Access Compliance Report

Public Rights-of-Way

Intersection ID: 44417	Main Street: MARVIN_RD	Cross Street: ARDREY_KELL_RD	Location: NW
ADA ID: F2BA350E8846	Ramp Type: Perp	Initial Pass/Fail: Fail	Overall Compliance: No
		Severity Score: 8.75	
Codes/Mitigation Info/Possible Solution		Field Measurements/Component Compliance

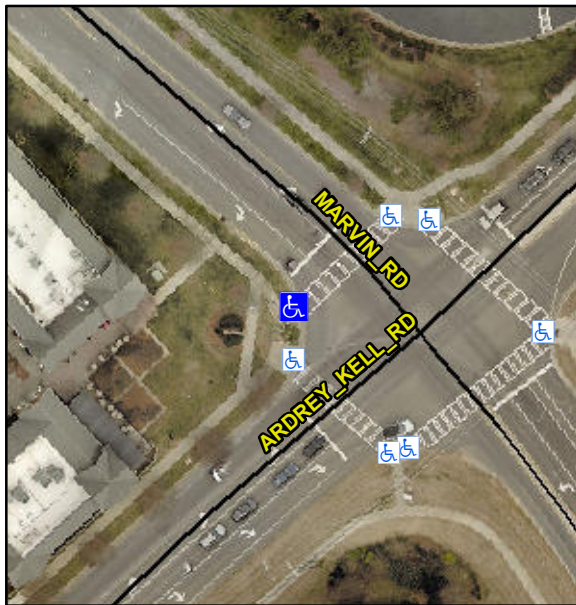
Not Found, R304.5.1

Compliance	Description	Data	Compliance	Description	Data
N/A	Ramp Length (in)	96.0	Yes	Ramp Slope (%)	6.3
No	Ramp Width (in)	47.0	Yes	Ramp XSlope (%)	1.6
N/A	Flare Type LT	N/A	N/A	Flare Type RT	N/A
N/A	Flare Slope LT (%)	N/A	N/A	Flare Slope RT (%)	N/A
N/A	Flare Traversable LT?	N/A	N/A	Flare Traversable RT?	N/A
N/A	Landing Length (in)	N/A	N/A	DWS Provided?	N/A
N/A	Landing Width (in)	N/A	N/A	DWS Contrast?	N/A
N/A	Landing Slope (%)	N/A	N/A	DWS Length (in)	N/A
N/A	Landing X Slope (%)	N/A	N/A	DWS Full Width?	N/A
N/A	Landing Curb? (Y/N)	N/A	N/A	DWS Offset (in)	N/A
N/A	Shared Landing?	N/A			
N/A	Gutter Ponding?	N/A	N/A	Gutter Slope (%)	N/A
N/A	Gutter Lip Ht (in)	1.5	N/A	Gutter X Slope (%)	N/A
N/A	Painted X Walk1?	Yes	N/A	Painted X Walk2?	N/A
	X Walk 1 Direction	To NE		X Walk 2 Direction	N/A
N/A	X Walk 1 Width (in)	113.0	N/A	X Walk 2 Width (in)	N/A
	X Walk 1 Slope (%)	3.5		X Walk 2 Slope (%)	N/A
	X Walk 1 X Slope (%)	0.0		X Walk 2 X Slope (%)	N/A

Remove & Replace Entire Ramp.
